# US 1/SR 4 Widening and Oak Park Bypass

EDS-545(14)(17)(18) Toombs and Emanuel Counties

## Value Engineering Study Report Preliminary Design Stage

### TYPICAL SECTION NO. 3

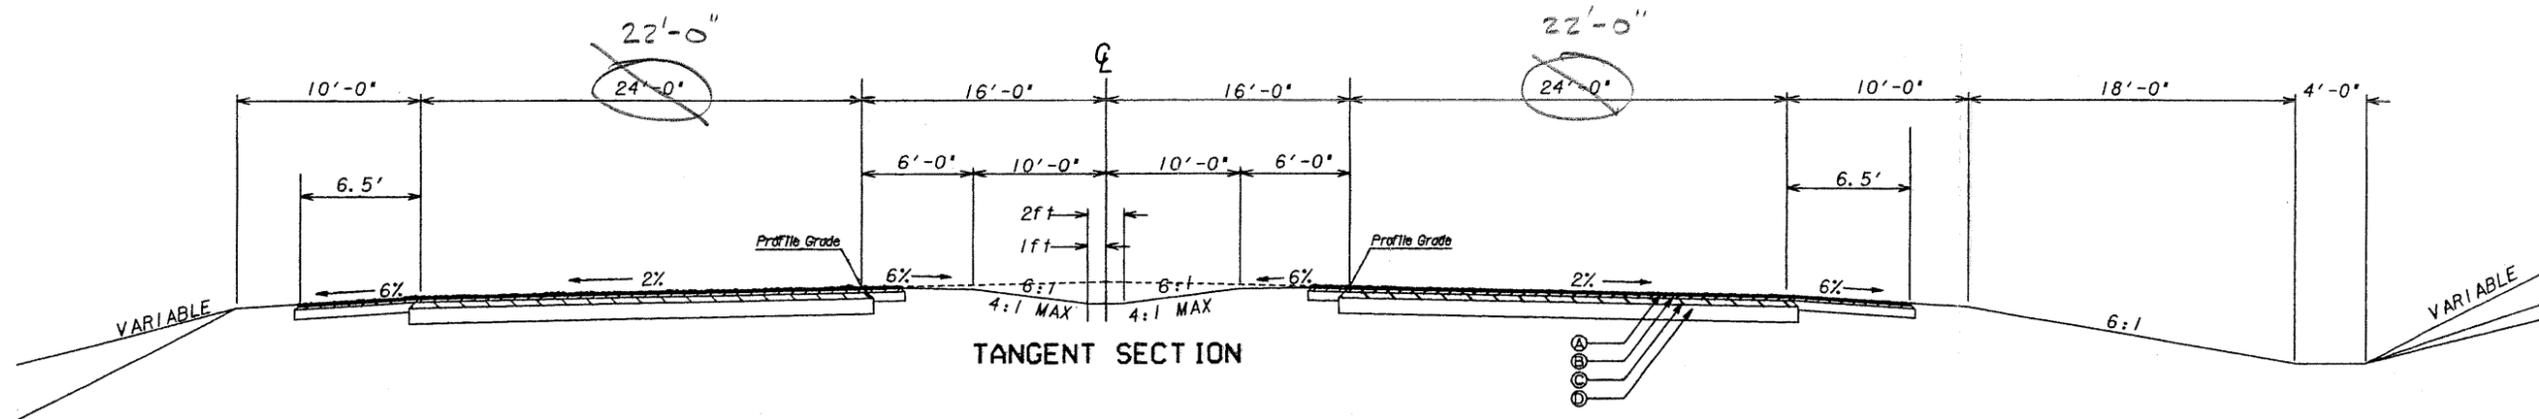
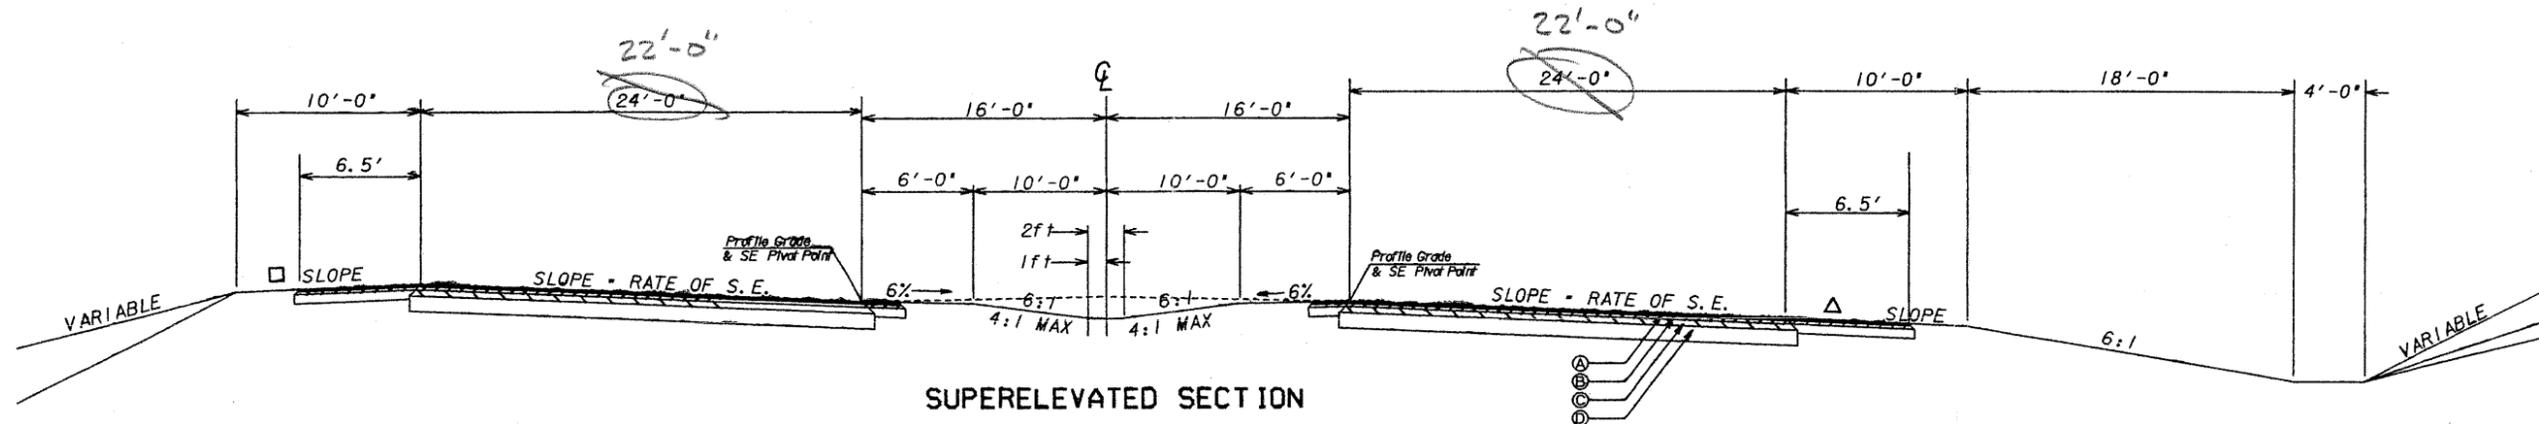
Eleven-ft. lanes, while slightly reducing safety, greatly reduce construction cost. The cost reduction makes this alternate worth investigating.

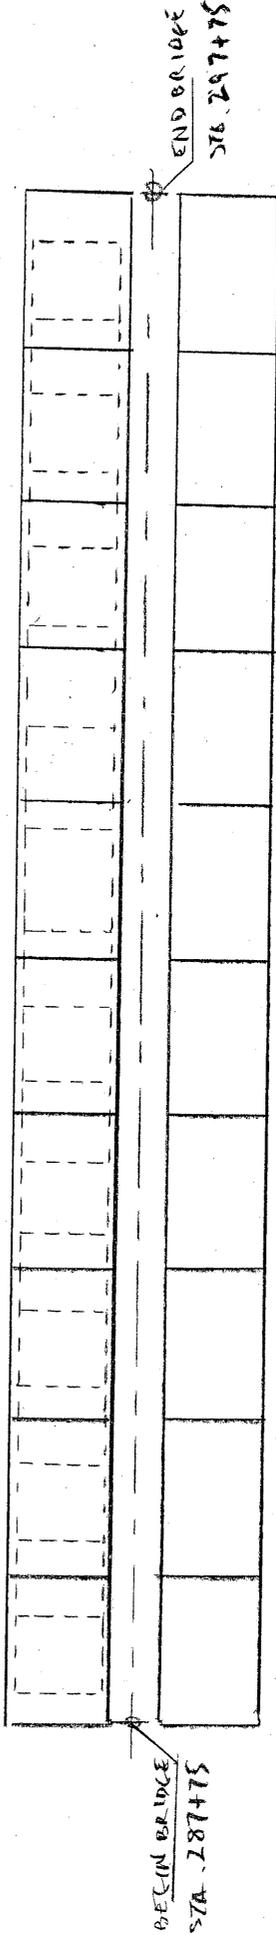
By offsetting the beginning bent by 10 ft., all new bents miss the existing bents by at least 10 ft. Missing the bents seems to be the idea behind the multiple span arrangement in the original design and a uniform span length will satisfy this requirement. The bridge will be shorter by 20 ft. and bents 6 through 9 can be pile bents instead of the more expensive concrete intermediate bents.

PROJECT:	<b>EDS-545 (14) (17) (18) US 1/SR 4 WIDENING &amp; BYPASS</b> <i>Georgia Department of Transportation</i>	ALTERNATIVE NO.:	<b>B-3</b>
DESCRIPTION:	<b>MINIMIZE THE NUMBER OF BENTS AT THE US 1 BRIDGE OVER THE OHOOPEE RIVER</b>	SHEET NO.:	<b>1 of 5</b>

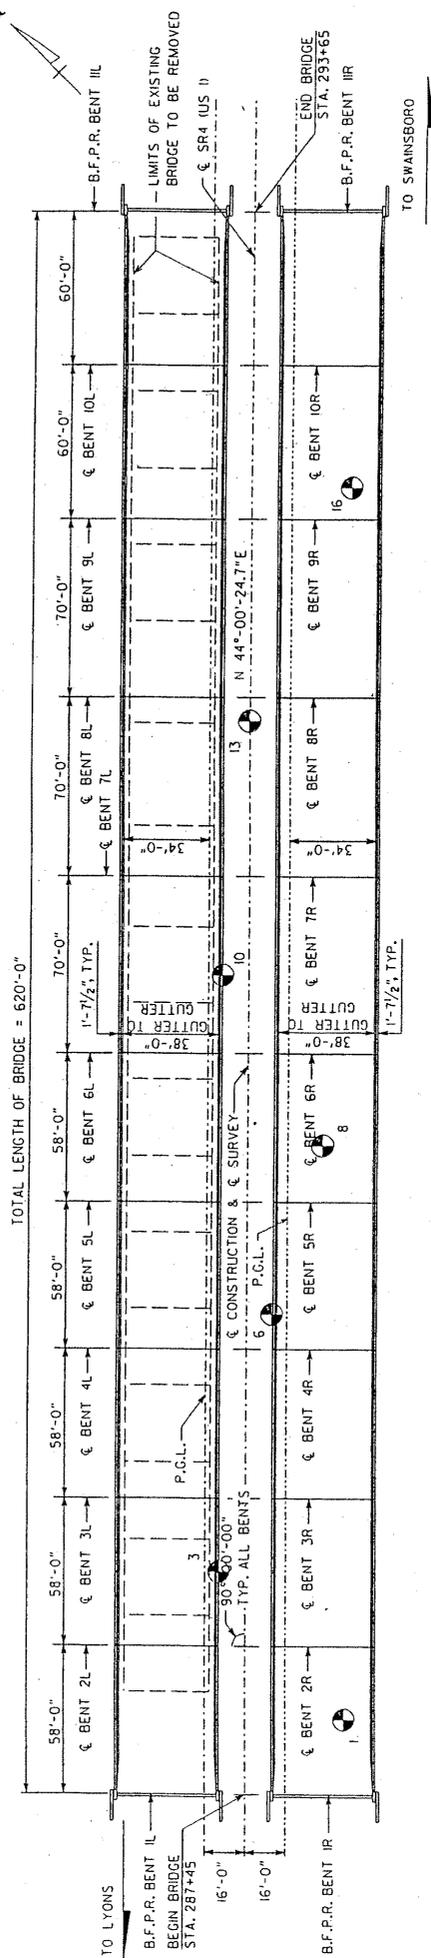
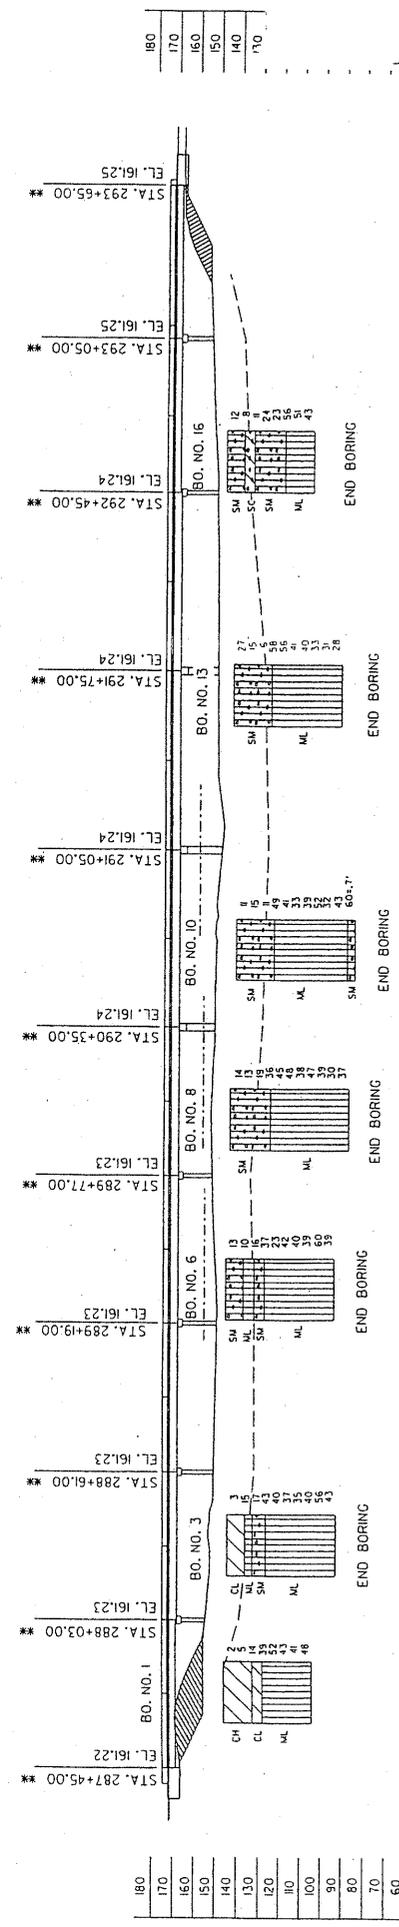
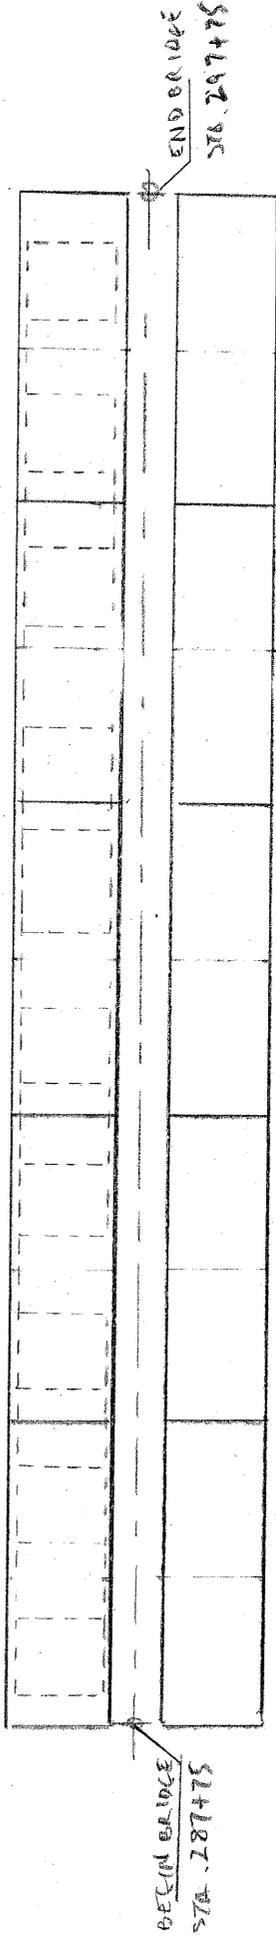
Decreasing the number of intermediate bents from 9 to 4 means less area of disturbance. Although this would mean an increase in cost for PSC beams and bents, the cost increase will be offset by the elimination of the pile bents.

Although this alternative increases initial costs, it would reduce contract growth potential due to the minimization of driving piles and less construction time in the floodway.

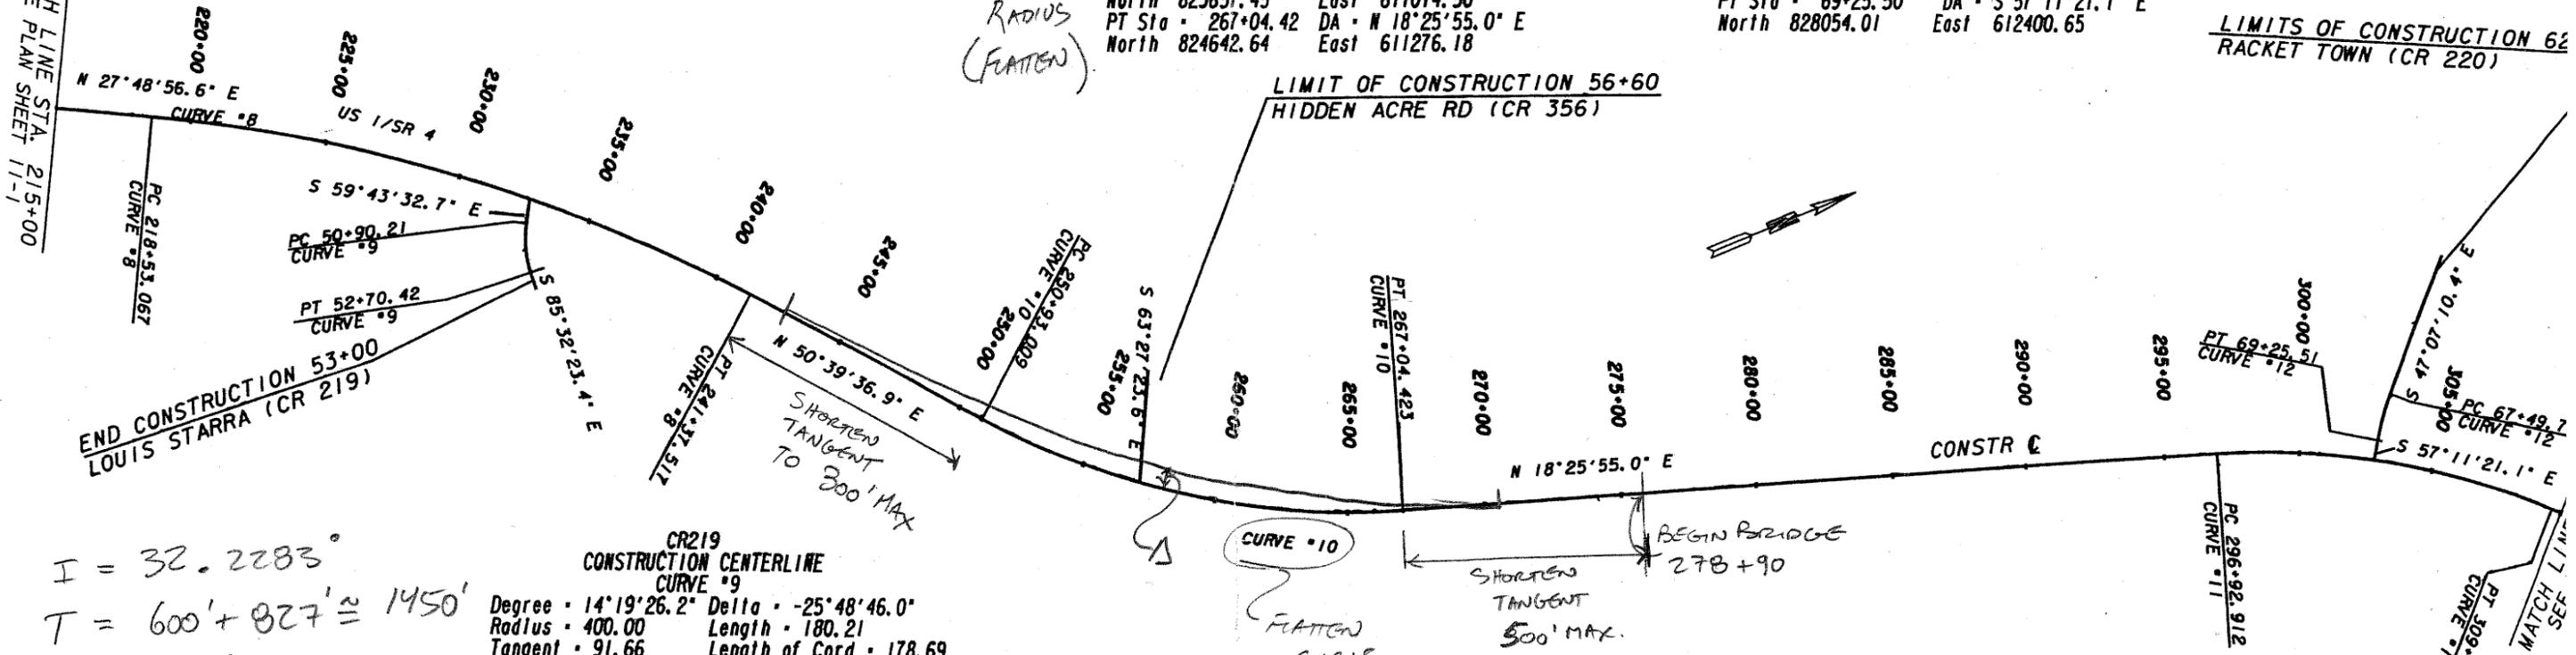
$I = 32.2283^\circ$   
 $T = 600' + 827' \approx 1450'$   
 $R = \frac{1450'}{\tan(\frac{1}{2}(32.2283))} = 5019.0$

DESCRIPTION: **MODIFY REVERSING CURVES NEAR HISTORIC PROPERTY (UNION CAMP TAX DEPARTMENT) BY TRANSITIONING WIDENING TO THE EAST SIDE AND PARALLEL EXISTING ALIGNMENT TO THE NORTH** SHEET NO.: **1 of 3**

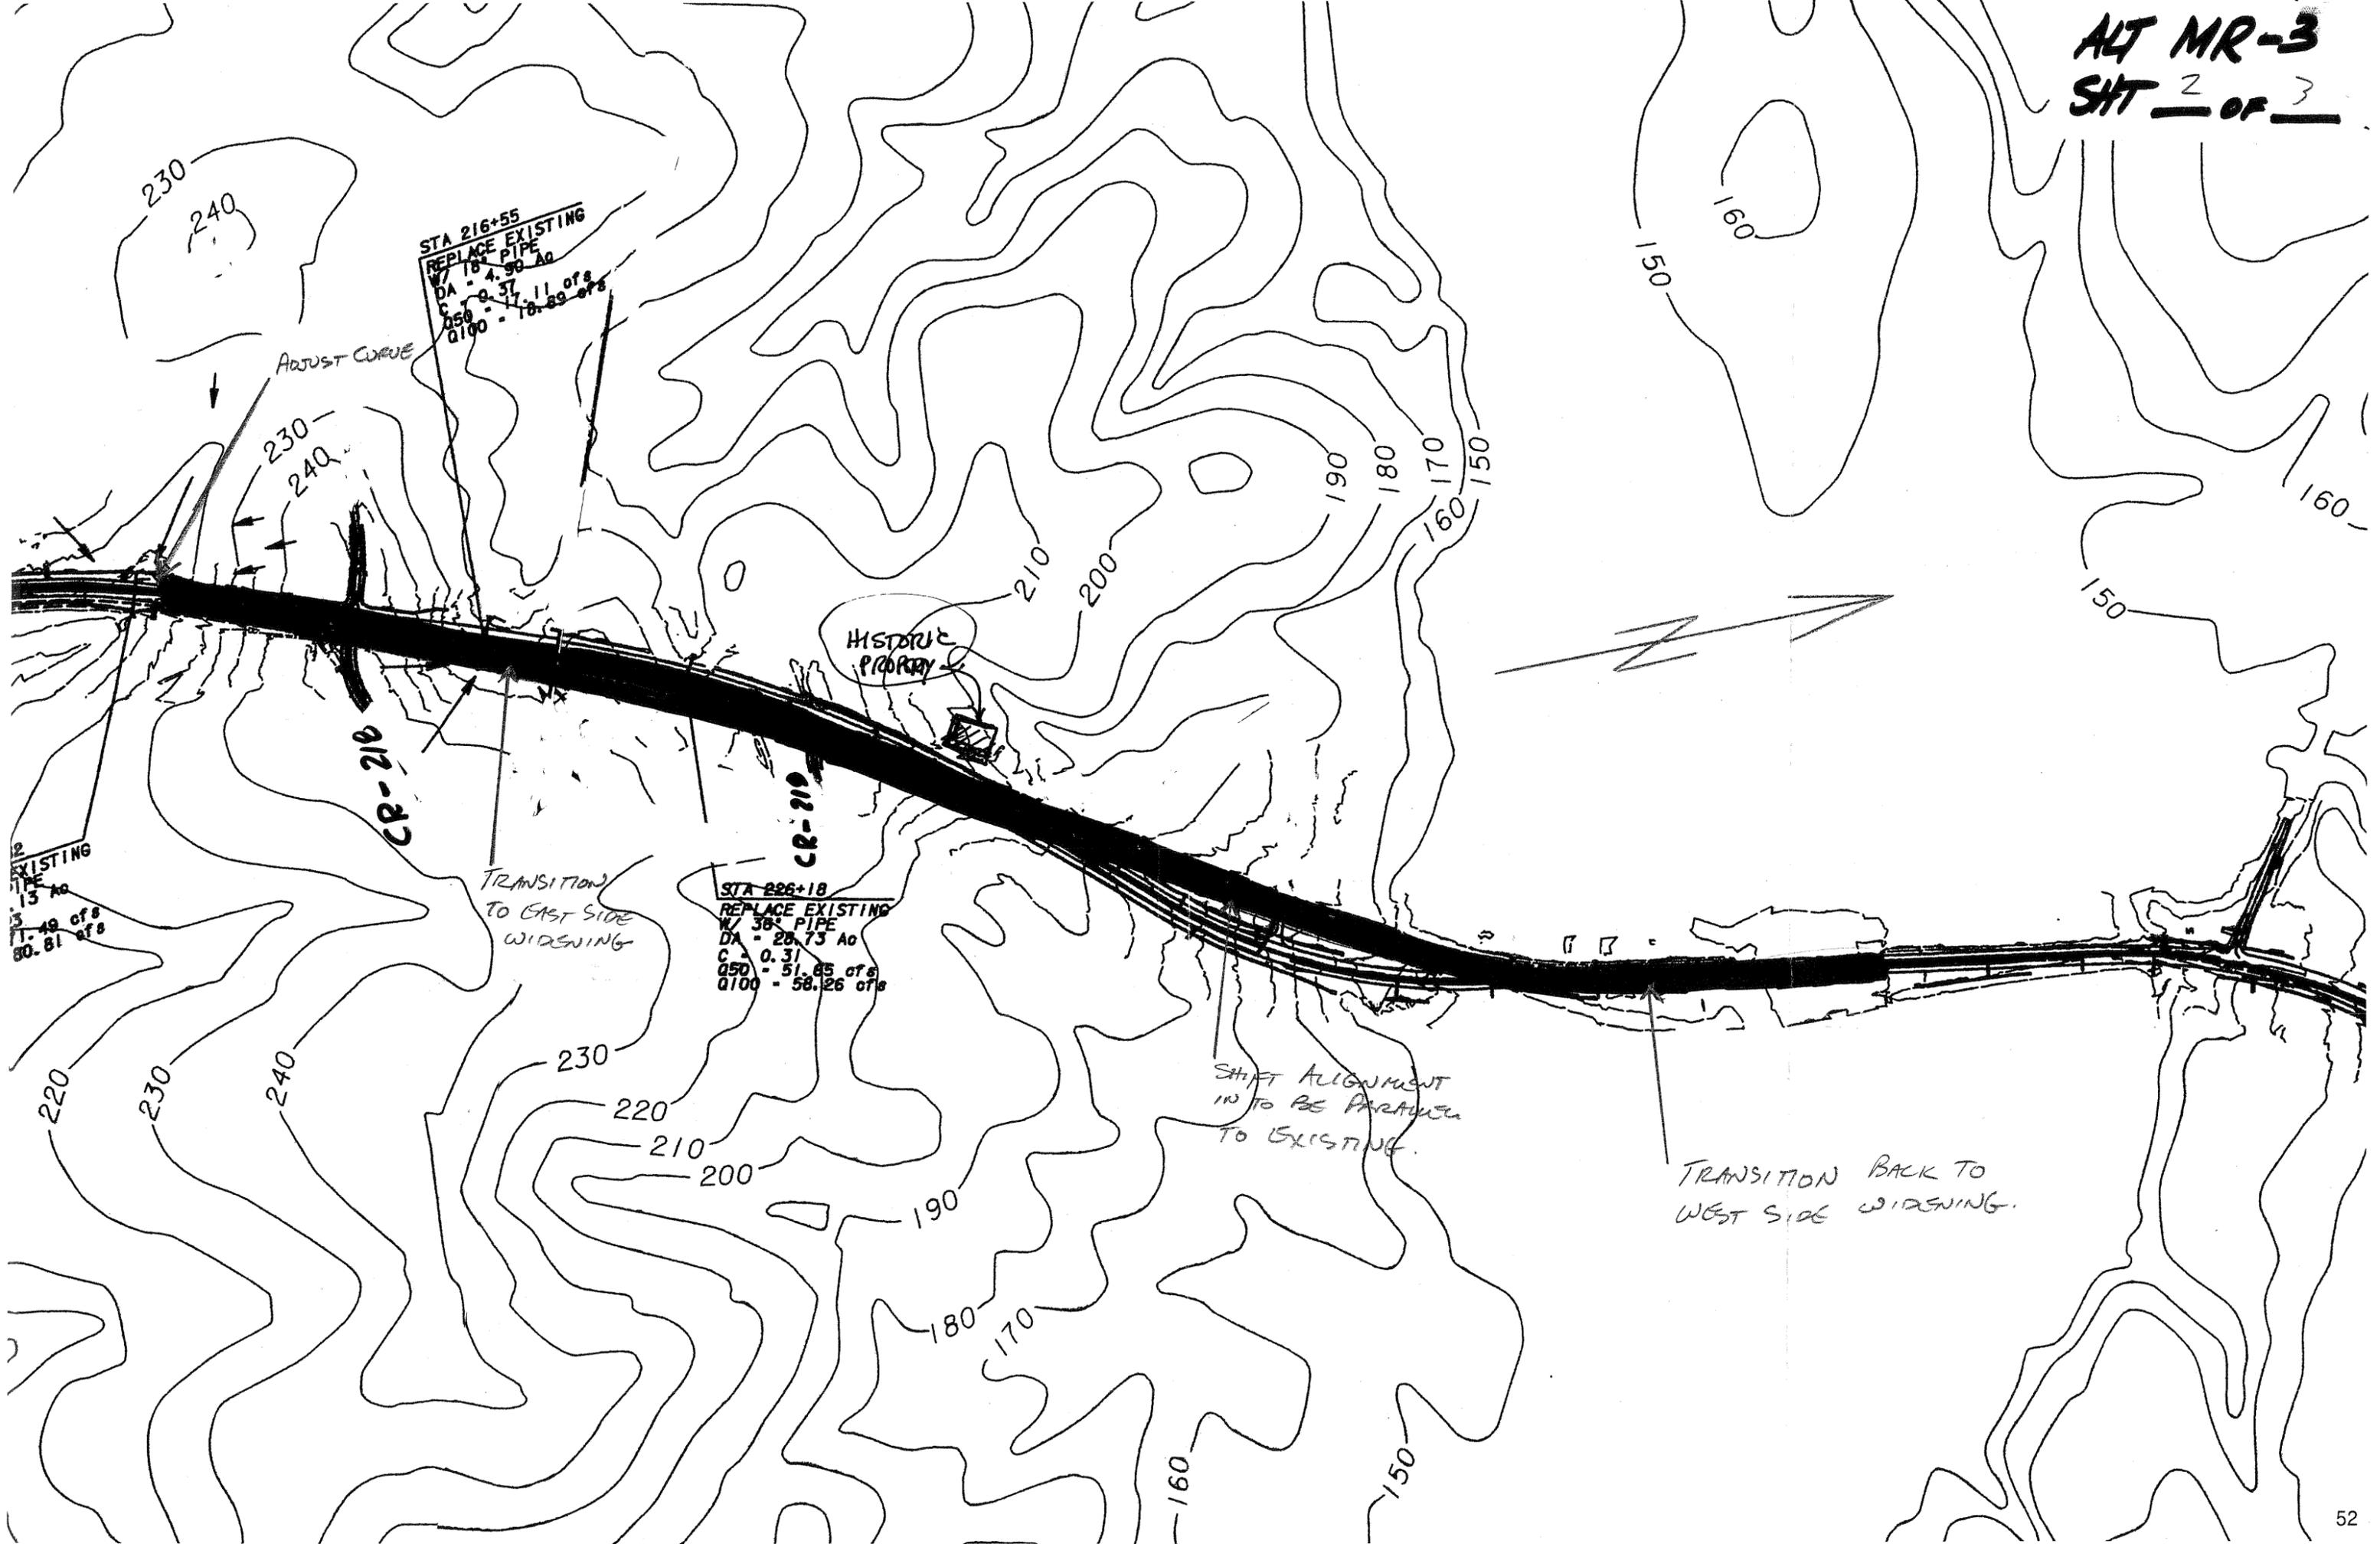
- Eliminates the wide swath of land currently being used
- Less right-of-way required
- Smoother alignments
- Allows use of existing pavement
- Less wetlands disturbance
- Reduces costs

- May impact properties on east side of existing highway at CR-219 intersection
